**ADDENDUM #1
Public Works - Building Services Division
Justice Center 1st Floor Tile Replacement
BID # 7207-21**

February 16, 2021

JC- FIRST FLOOR TILE REPLACEMENT

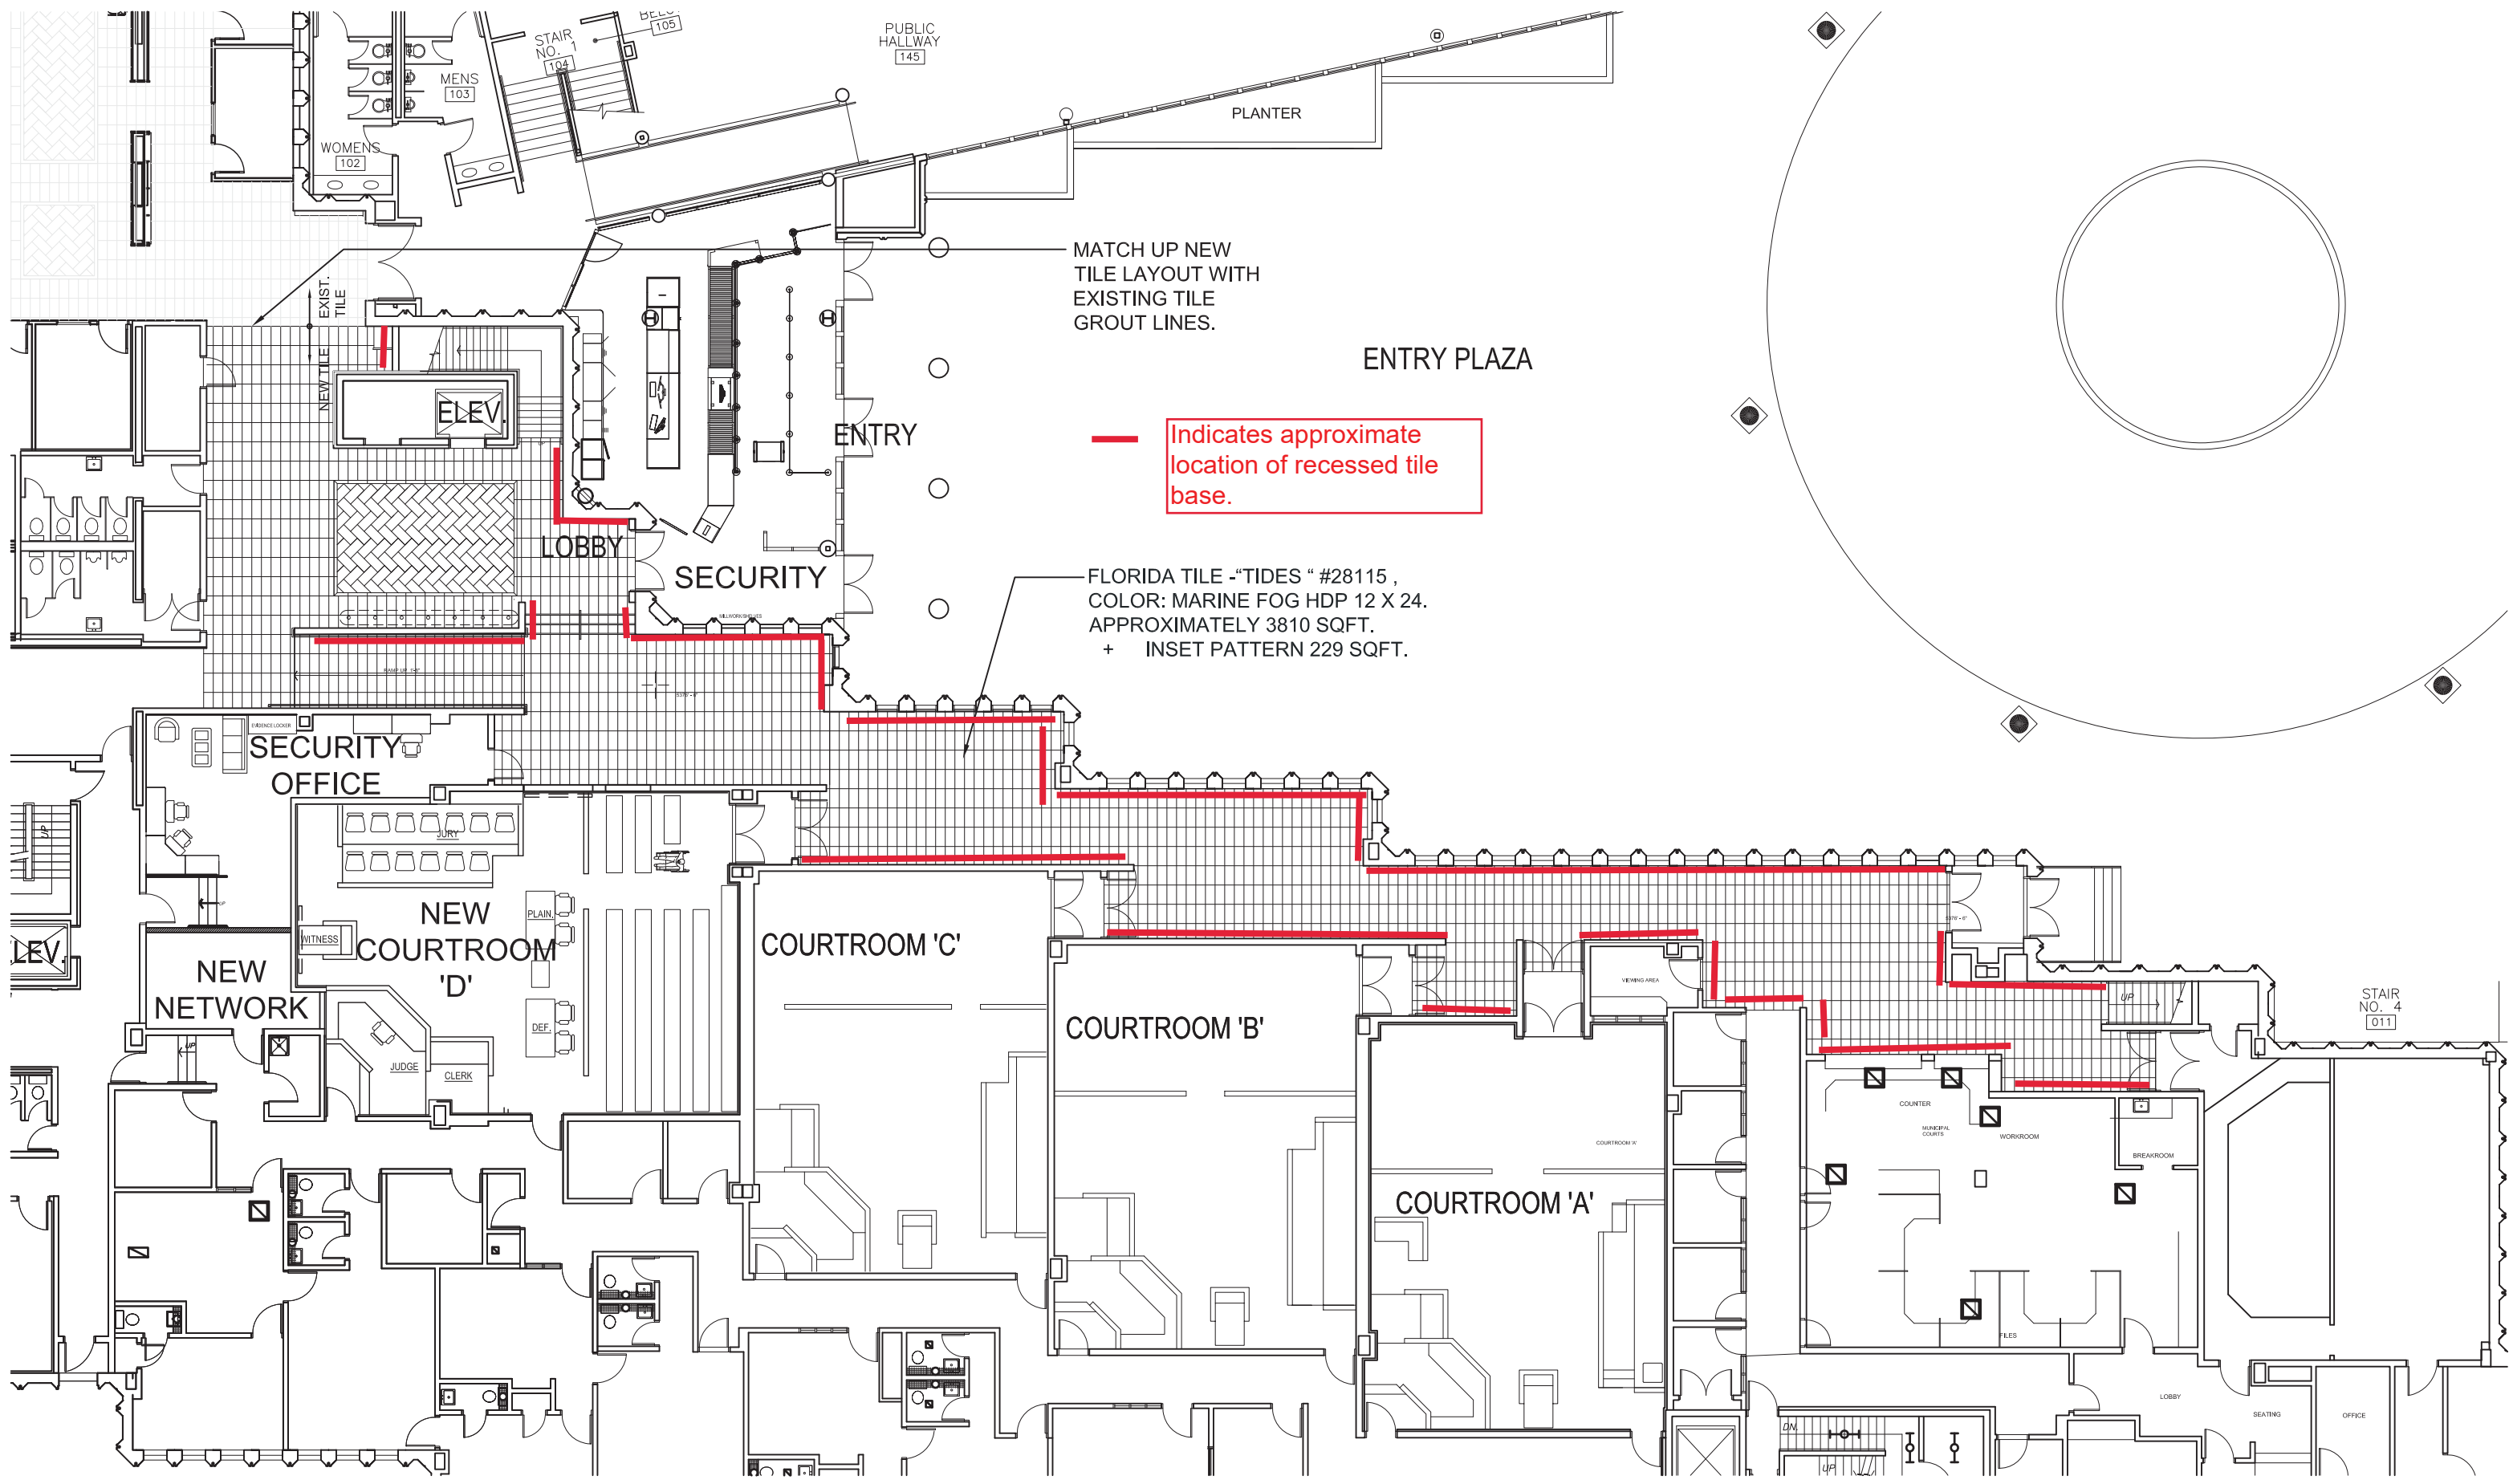
5. Question: I did not see wall tile in the project scope, but there is grout spec'd for wall tile. Will there be cover base installed, and not the sluter (sp?) transition? Or am I missing something from the package?

See JC -Tile Recess detail found in the bid package, and the JC-First Floor Tile replacement ADD 1-02-16-21 and existing corridor photograph attached at the end of this document.

ANSWER: There is no wall tile to be installed on the project but a Ceramic tile base is required. The new ceramic tile base will be applied on the existing CMU walls that have a 1" recess at the base. Note: existing tile base is to be removed before installing new base.

— Indicates approximate
location of recessed tile
base.
